West Burton Solar Project

Statement of Common Ground with Historic England Revision A

PINS reference: EN010132
Document reference: EX5/WB8.3.3_A

Figure 1. Location of heritage assets associated with Stow Park Deer Park, Stow Deserted Medieval Village and a possible early medieval settlement in the west of West Burton 3.

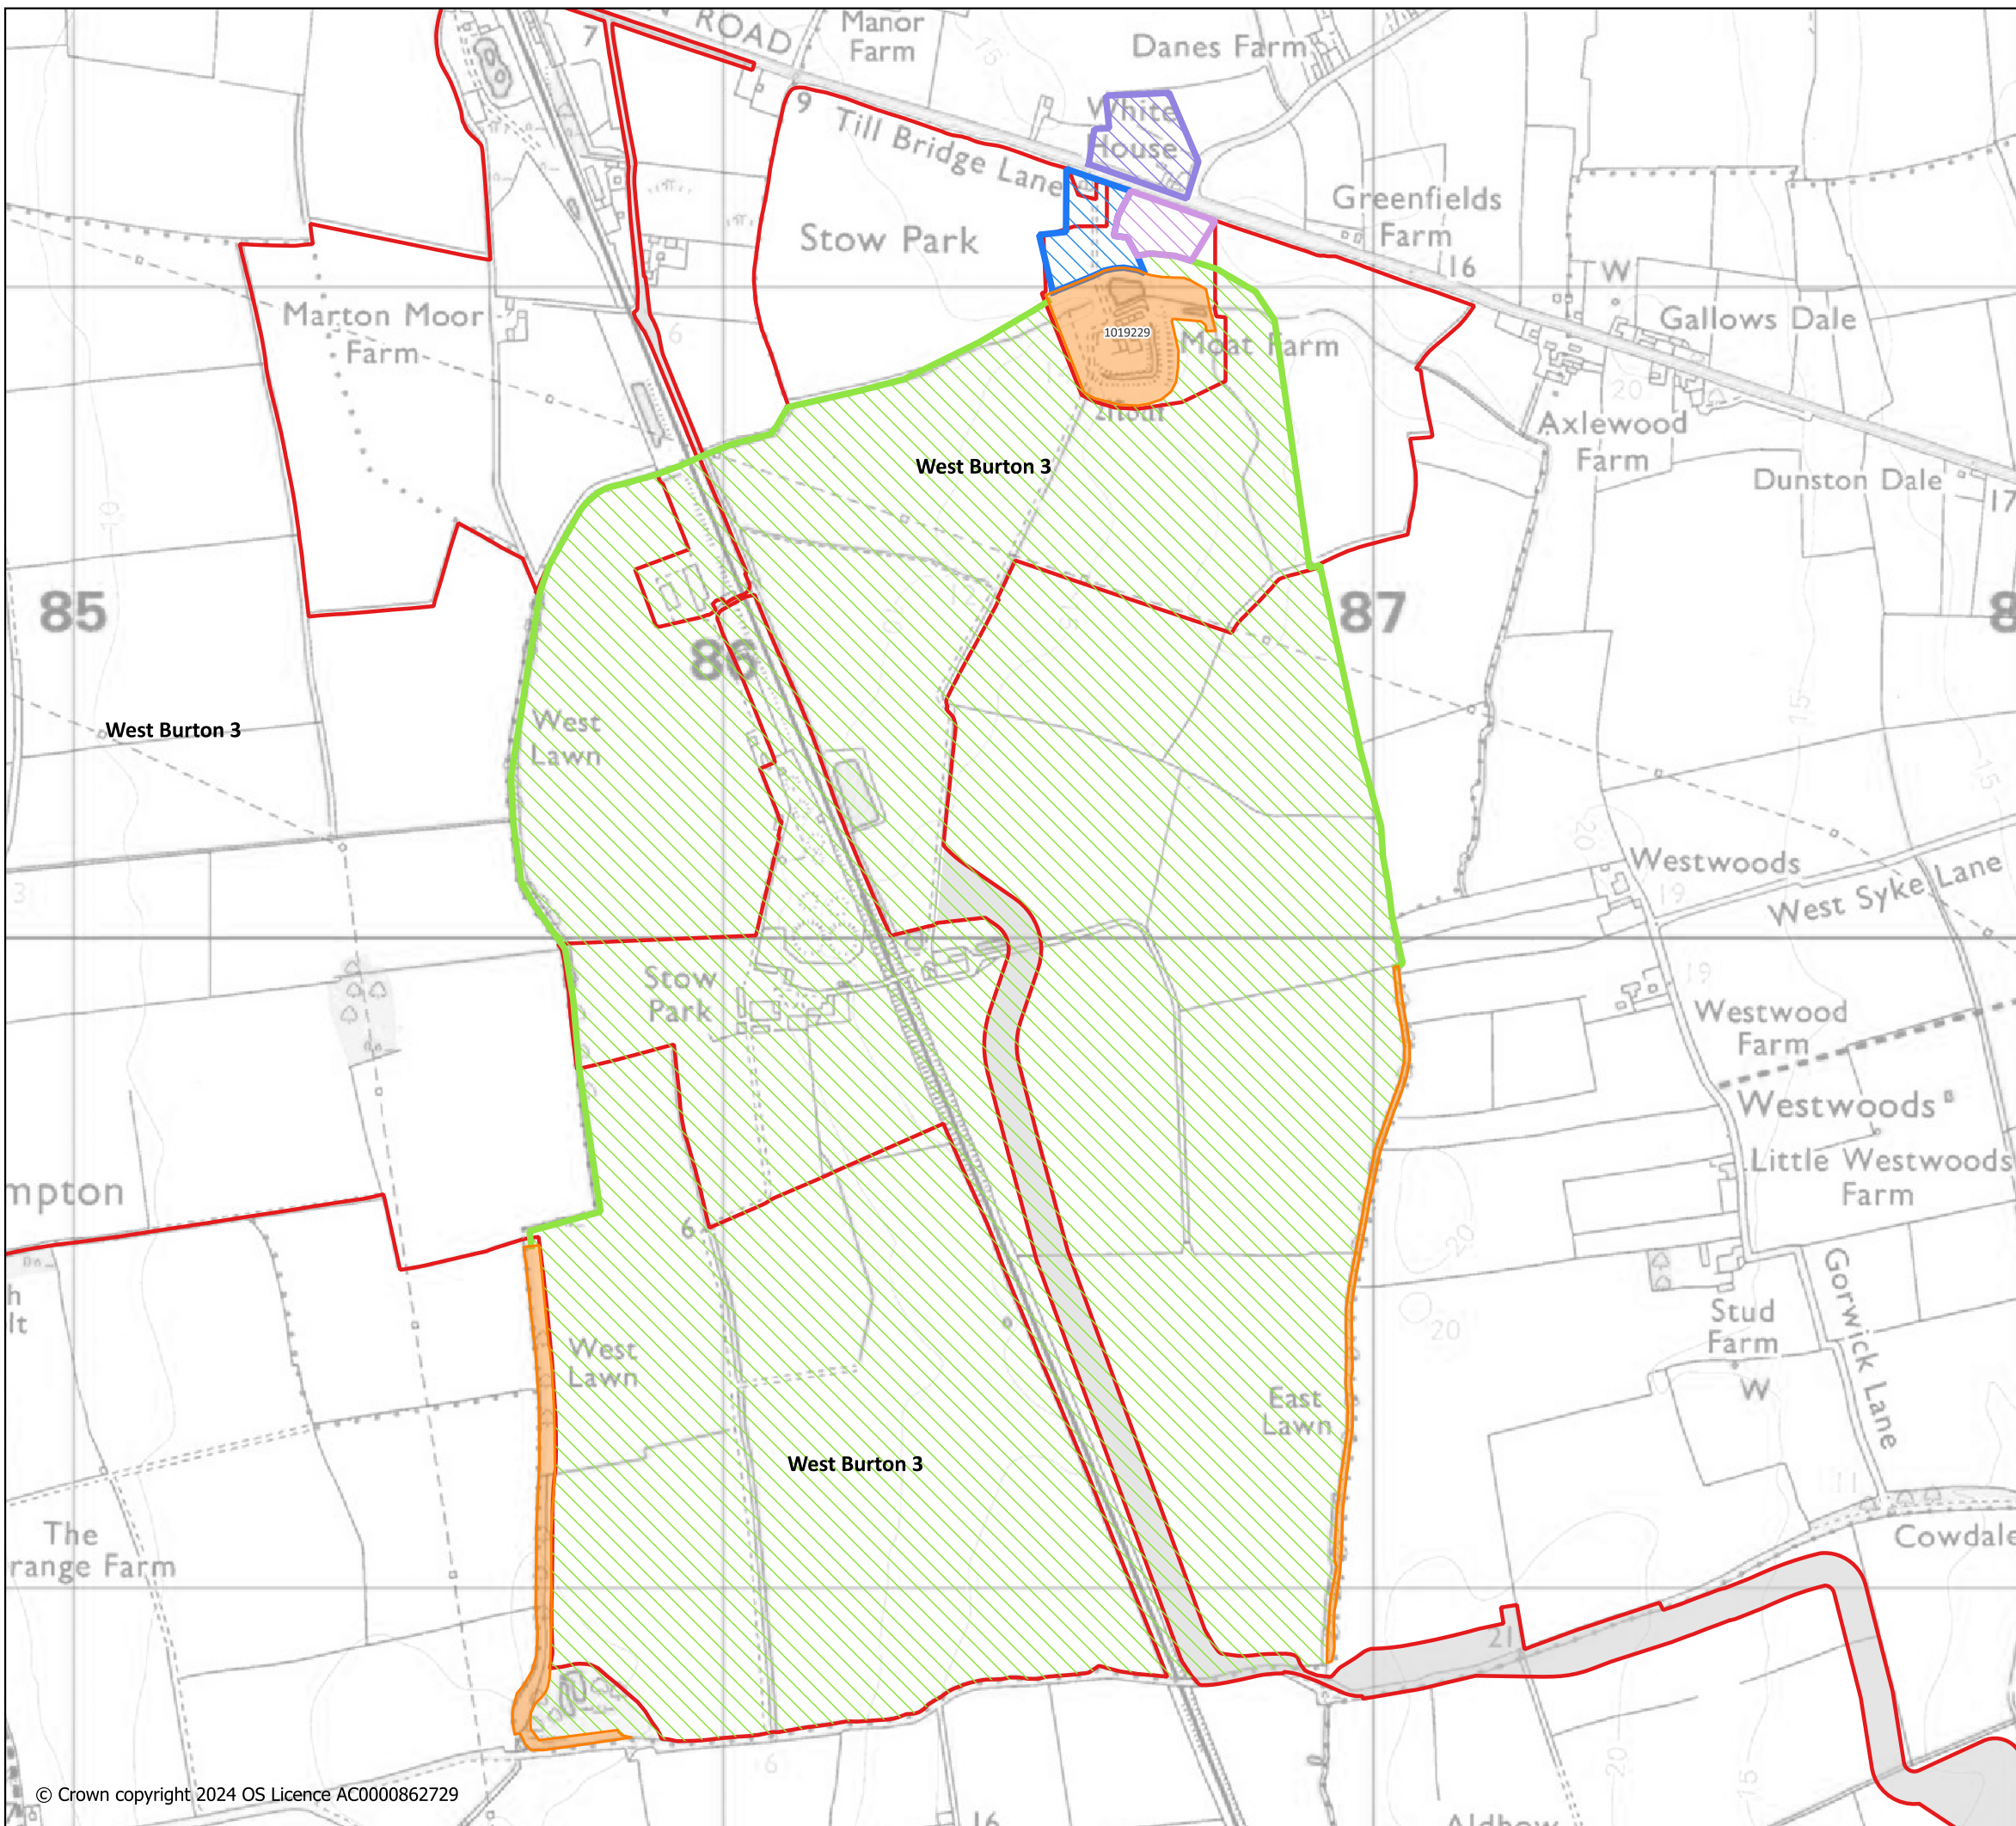
Item	Applicant Position	Historic England Position
Level of harm	<p>The Applicant believes that Scheme would cause less than substantial harm (at the upper end) to the significance of Medieval Bishop’s Palace and Deer Park, Stow Park Scheduled Monument (NHLE 1019229), which is derived from changes to its setting through the introduction of solar panels.</p> <p>The introduction of solar panels would not cause direct harm to the fabric of the three isolated elements that constitute the Scheduled Monument and that form the only surviving vestiges of the Deer Park. Due to the distances between these elements of Scheduled Monument and the lack of coherent sightlines, the legibility of the landscape would be unaltered and the reversible nature of the Scheme means that any harm to the setting of the Scheduled Monument</p>	<p>HE considers that the impact of the Scheme on land within the former Deer Park as defined by Medieval bishop’s palace and Deer Park, Stow Park Scheduled Monument (NHLE 1019229) would cause substantial harm (in NPS/NPPF terms) / significant environmental impact (major harmful; in EIA terms) to the significance of the Scheduled Monument through loss of its character as a bounded architectural space. Consequently HE <i>“object to installation of any part of the development within the former Deer Park (as defined by the lines of the scheduled Park Pale and its former course).”</i></p> <p>For extent of the Deer Park see the appended agreed map.</p>
